PREVOST

WARRANTY BULLETIN

Wb97-09

SUBJECT: RELAY R39 & R41 REPLACEMENT

FIGURE 2: LOCATION OF RELAYS

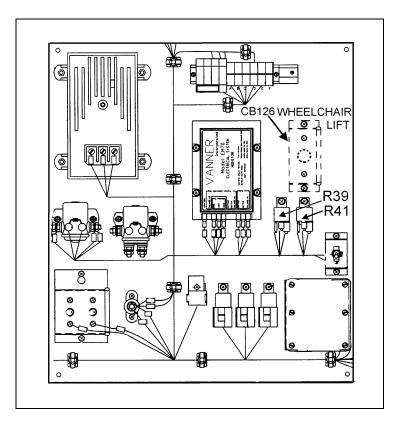
- 2. Locate relay R39 and R41, refer to figure 2 to ease identification of relay R39 and R41.
- 3. Remove screws and washers retaining relay R39 and R41, cut each wire near terminal, then discard relays and fasteners.

Note: Vehicles equipped with wheelchair lift system have a circuit breaker (CB126) installed just over relay R39 and R41. This circuit breaker must be removed and reinstall in the upper right hand corner of the same panel.

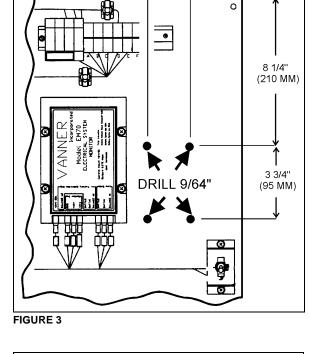
4. Referring to figure 3, drill 4 holes using a 9/64" (3,6 mm) diameter bit.

Caution: Drill only the panel, do not drill through the compartment back wall.

FIGURE 4

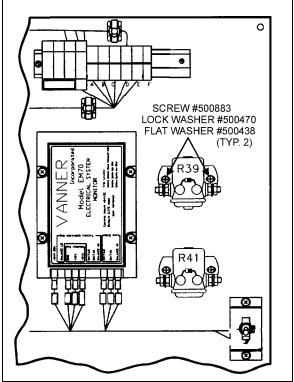
- 5. Position relay R39 as illustrated in figure 4, then fix using tapping screws (#500883), lock washers (#500470) and flat washers (#500438).
- 6. Position relay R41 as illustrated in figure 4, then fix using tapping screws (#500883), lock washers (#500470) and flat washers (#500438).

FIGURE 5 06212

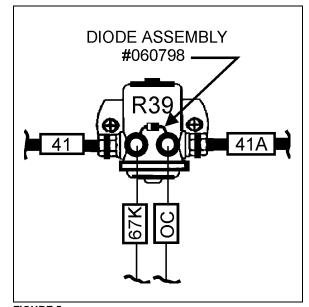
7. Strip extremity of wire #41, crimp a ring terminal (#561246) then connect to relay R39 as illustrated in figure 5. Tighten nut to 40 lbf•in maximum.

- 8. Strip extremity of wire # 41A, crimp a ring terminal (#561246) then connect to relay R39. Tighten nut to 40 lbf•in maximum.
- 9. Position diode assembly (#060798) on relay R39 as illustrated in figure 5, strip extremity of wire #67K, crimp a ring terminal (#560815) then connect to relay R39. Tighten nut to 20 lbf•in maximum.

Caution: Ensure to correctly position diode assembly as illustrated in figure 5.
